ADDENDUM NO. 1
AUGUST 25, 2017
CORPORATE DRIVE AND GOOSEBAY DRIVE SEWER IMPROVEMENTS
PORTSMOUTH, NEW HAMPSHIRE

The following changes and information are hereby incorporated into the Contract Documents (Project Manual and Drawings).

BIDDER REQUEST FOR INFORMATION & ENGINEER RESPONSES

EXISTING SEWERAGE SYSTEM FLOWS

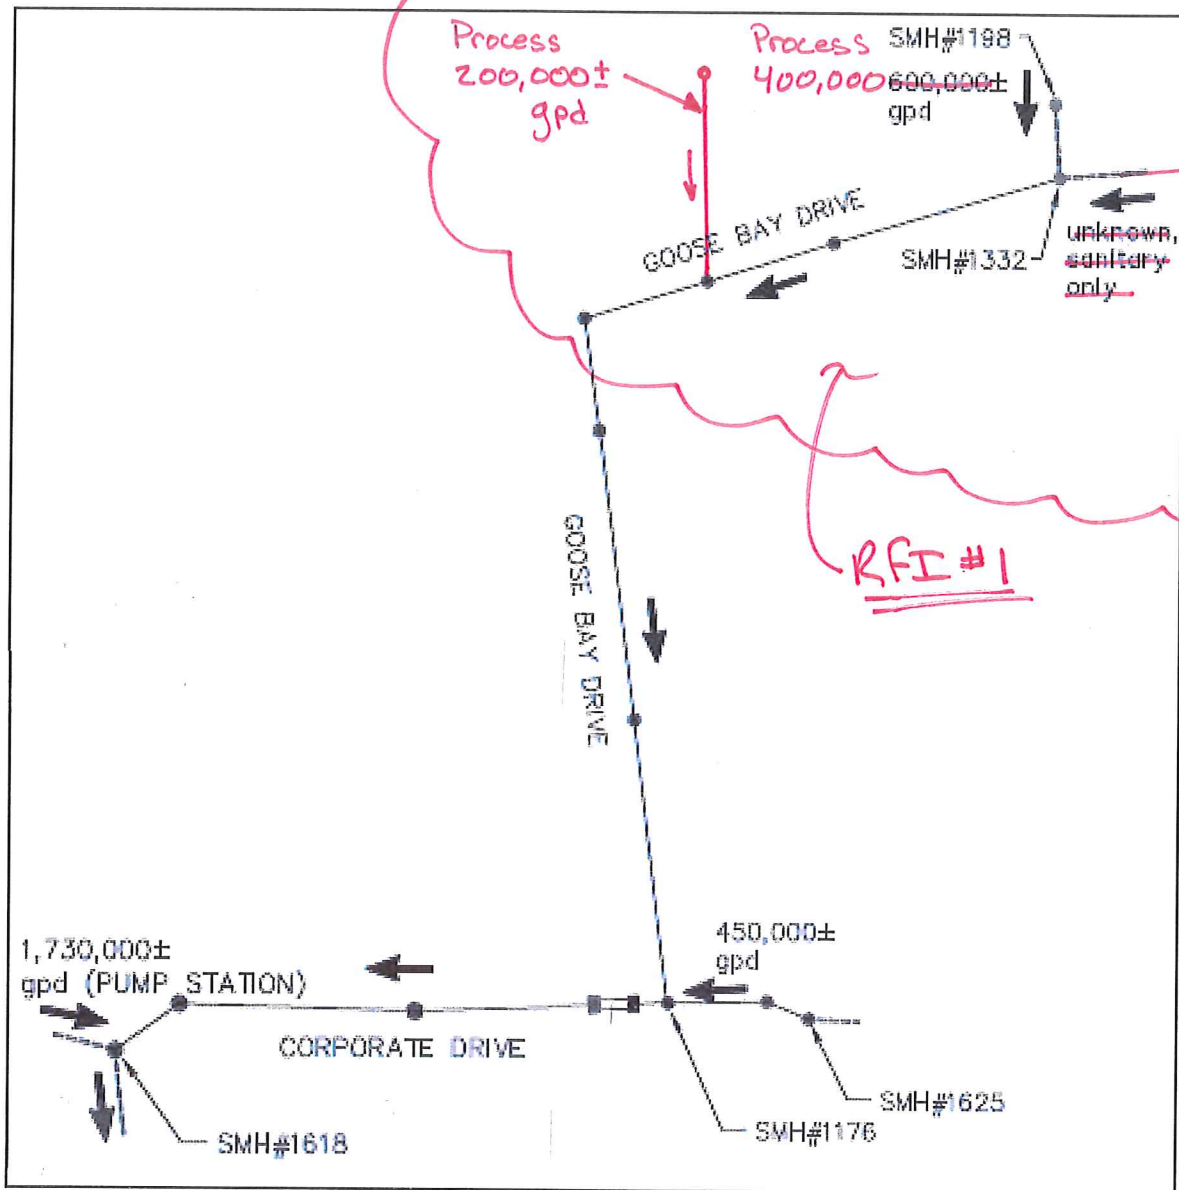
RFI #1: The existing 12" fip sewer line from the south at STA. 19+50 does not have flows listed on the "Existing Sewerage System Flows" diagram. Please provide flows for this sewer line as it will need to be bypass for construction.

RFI #12: The force main that discharges to SMH 1632 indicates at peak discharge of 1,200 GPM. What is the frequency and duration of the pump cycles and what is the capacity of the pump station?

Response: Sewerage flows from Lonza into the sewerage system are summarized as follows (see attached "Existing Sewerage System Flows Diagram Revised 8/24/17"):

- *Flow into 12" fip at proposed SMH #10 is process flow = 200,000 GPD +/-*
- *Flow into existing smh 1332 is process flow = 400,000 GPD +/-*
- *Flow into existing smh 1428 is sanitary flow = 10,000 GPD +/-*

Response: The Contractor will need to coordinate maintenance of pump station flows with the City. The station is a triplex station and the Owner reports a typical flow rate of around 600 gpm but the station does have the capacity of higher flow rates as noted on the drawings. It is also reported that the station has an approximate runtime of 3.5 minutes per cycle (at 600 gpm) and that each pump in the station operate for approximately 30 minutes per day. Additionally an unknown amount of gravity flows enter the system at existing SMH #1632.
